SERVICE BULLETIN

TS-940S SIGNAL TO NOISE RATIO IMPROVEMENT

8-28-86

IF UNIT (X48-1430-00)

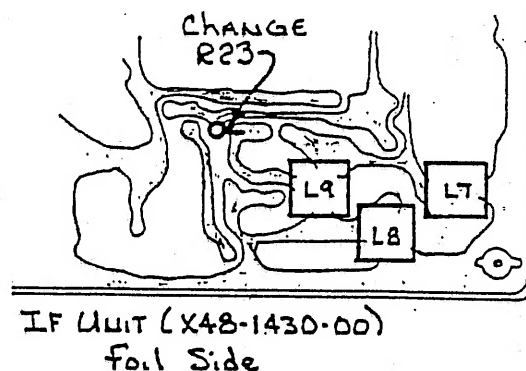
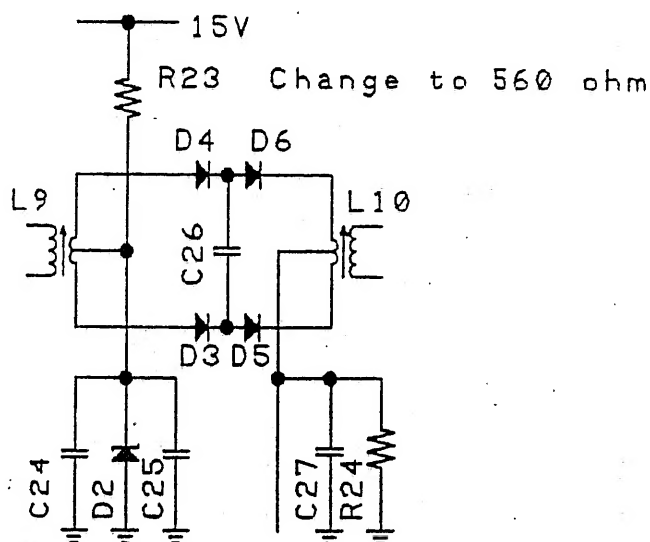
The following change will reduce the tendency of the Zener Diode in the Noise Blanker circuit to cause an increase in the ambient noise level. This change ensures that no current flows thru this diode in the normal receive position.

On the IF UNIT (X48-1430-00) change R23 from 330 ohms to 560 ohms.

560 ohm 1/4 watt resistorRD14CB2E561J
